FINAL PLAT

THE GATEWAY CENTER ADDITION

RE: S/D 99-2 -- Final Plat of THE GATEWAY CENTER ADDITION

RE: S/D 99-2 -- Final Plat of THE GATEWAY CENTER ADDITION

FINAL PLAT
THE GATEWAY CENTER ADDITION
 AN ADDITION TO WICHITA, SEDGWICK COUNTY, KANSAS

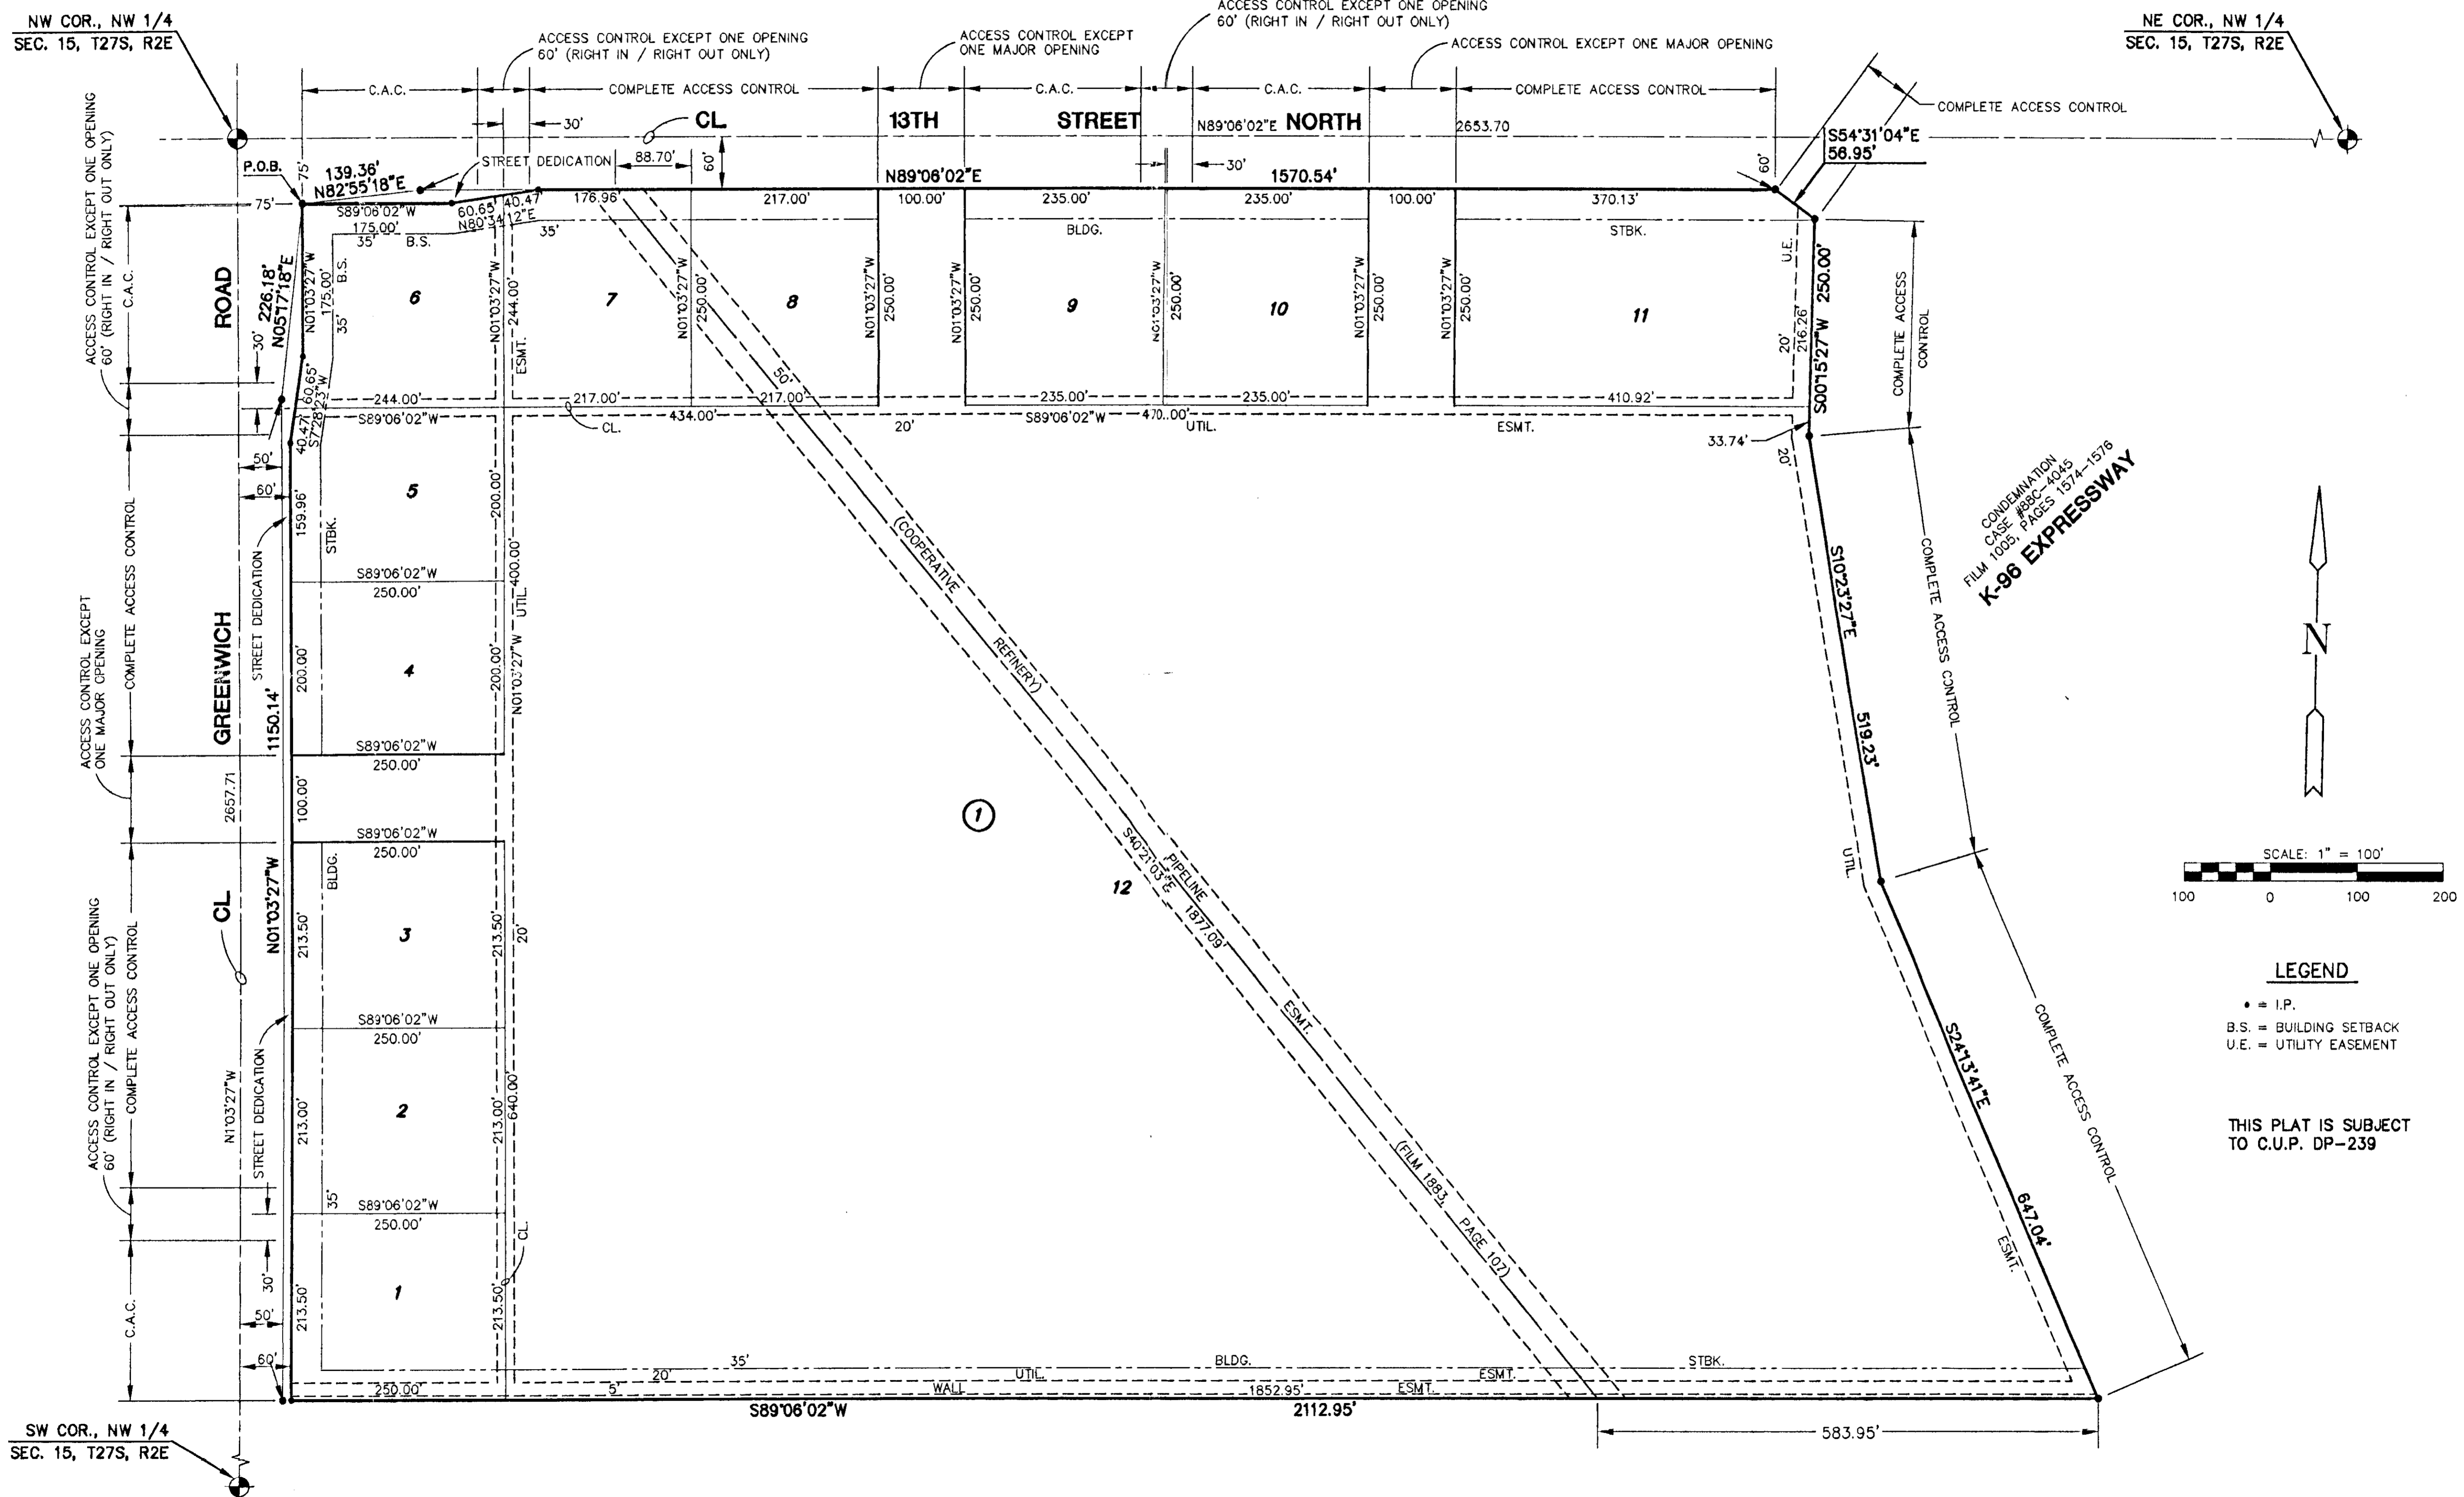
- A. As this site is adjacent to Wichita's City limits, the applicant shall submit a request for annexation. If the applicant desires to complete the plat prior to annexation, both the City and County signature blocks need to be included on the final plat.

- B. This plat will be subject to approval of the associated zone change (SCZ-0783) and CUP (DP-239) and any related conditions.
- C. This site is located in the County's Four Mile Creek sewer system and will be served by the County. County Engineering requires the submission of an off-site sanitary sewer easement.

- G. City Engineering needs to comment on the status of the applicant's drainage plan. An off-site drainage easement is required. A guarantee is required for drainage improvements.

- H. The plat denotes five access openings to Greenwich Road and seven access openings along 13th St. North. The Subdivision regulations encourage shared access points for multiple lot commercial subdivisions along arterials.

Traffic Engineering needs to comment on the acceptability of the access controls. Any joint access easement shall be established by separate instrument. Distances should be shown for all segments of access control. Traffic Engineering has approved three openings from the property to Greenwich and four openings to 13th St. North. On Greenwich, the northernmost of the three openings is limited to right turns in and out. A joint access between lots 1 and 2, a major opening between lots 3 and 4, and a joint access between lots 5 and 6 are approved along Greenwich. On 13th St. North, two of the four permitted openings will be major openings (one shall align with Chapel Hill Road and the other shall align with the entrance to Dillons north of 13th Street North) with left and right turns, and the other two openings shall be limited to right turns in and out (one shall be a joint access opening between Lots 6 and 7 and the other shall be located between lots 9 and 10).

- I. The applicant shall submit a copy of the instrument which establishes the pipeline easement on the property, which verifies that the easement shown is sufficient and that utilities may be located adjacent to and within the easement. The final plat tracing shall also indicate the recording information for the pipeline easement.

- J. The applicant's agent shall determine any setback requirements for the pipelines by researching the text of the pipeline agreements. If a setback from the pipeline easements is provided for in the pipeline easement agreements, it shall be indicated on the face of the plat and further noted that the setback is a building setback line for the Farmland Industries pipeline.

- K. Traffic Engineering needs to comment on the need for any improvements to perimeter streets. In accordance with the zone change (SCZ-0783) and CUP (DP-239) Traffic Engineering has required the following: Along 13th Street North a continuous eastbound accel/decel lane shall be guaranteed from Greenwich to the K-96 on-ramp; plus a center median with two openings, one at Chapel Hill Road and the other to line up with the entrance to Dillons north of 13th St. North; if no median is constructed, the two minor openings shall be designed with raised diverter medians to only permit right-turn movements; and the applicant shall guarantee a portion of the cost of signalization at the intersection of 13th St. North and one of the major openings.

Along Greenwich Road, the Applicant shall guarantee a temporary left turn southbound lane as long as Greenwich remains a two lane road. The Applicant shall guarantee a permanent southbound left turn lane to the major opening when Greenwich becomes a four-lane road.

- L. A CUP Certificate shall be submitted for recording with the Register of Deeds prior to City Council consideration, identifying the approved CUP and its special conditions for development on this property.
- M. The final plat shall indicate that the Addition is subject to the conditions of the associated CUP.
- N. The name of all owners who are signatories on this plat must be printed beneath their signature.
- O. The applicant shall install or guarantee the installation of all utilities and facilities which are applicable and described in Article 8 of the MAPC Subdivision Regulations. (Water service and fire hydrants required by Article 8 for fire protection shall be as per the direction and approval of the Chief of the Fire Department.)
